Authorized Field Change

AFC 17913

Subject File: Uptime Improvements

Subject: Update Instrument Cluster, Body Control Module (BCM), Light Control Module (LCM), Switch Pack Modules, Stalk Shifter Module, Auto-Start Feature and Auxiliary Battery Interconnects.

Figure 5. Cummins Insite – PTO Switches

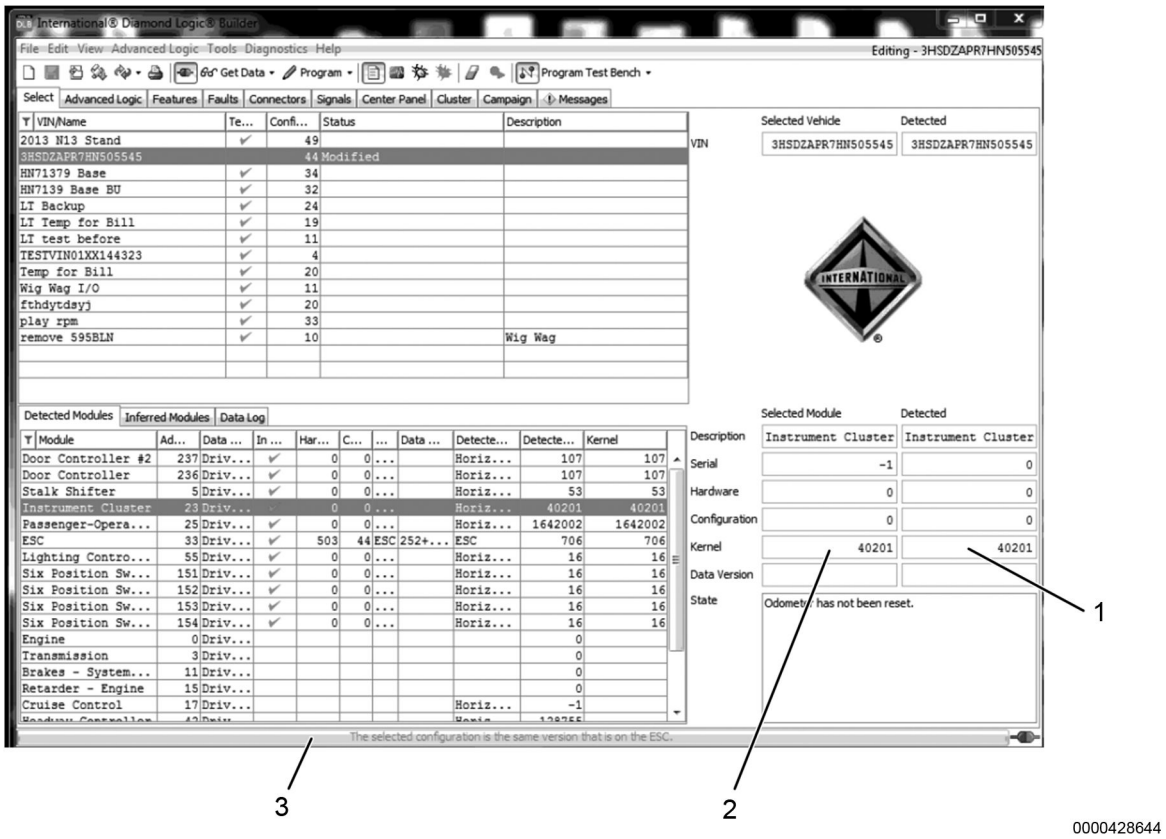
23. Locate PTO ON / OFF SWITCH and PTO SET / RESUME SWITCH. If necessary, select ENABLE function for both switches and verify source address for both switches are set to 33-BODY CONTROLLER (Figure 5).

Figure 6. Battery Interconnect Cables

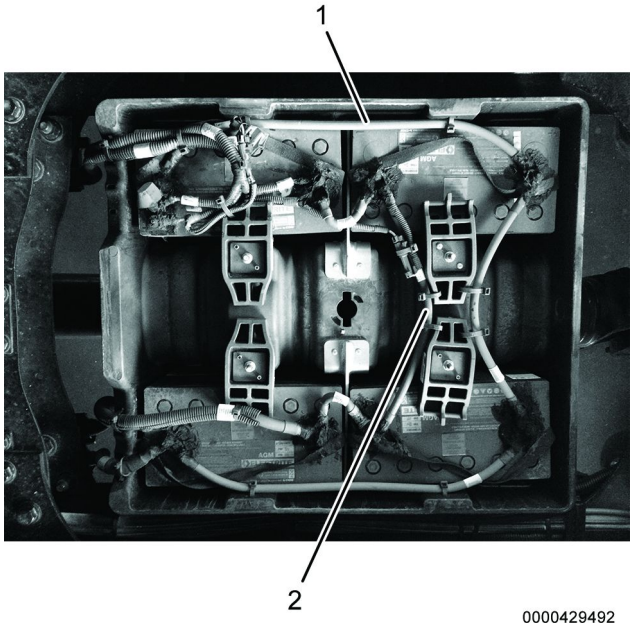
Multiple system module updates to mitigate false malfunction indicator light, Engine ECM parameter update, and replace auxiliary battery interconnect cables.

27. Cut tie straps and remove negative battery interconnect cable (Figure 6, Item 2).

28. Cut tie straps and remove positive battery interconnect cable (Figure 6, Item 1).

29. Install new negative battery interconnect cable.

30. Install new positive battery interconnect cable.

31. Using tie straps, secure negative and positive interconnect to same clipping points as cut in Steps 27 and 28.

32. Using a torque wrench, tighten positive battery post nuts to 142 - 177 lb-in (16 - 20 N•m).

33. Using a torque wrench, tighten negative battery post nuts to 142 - 177 lb-in (16 - 20 N•m).
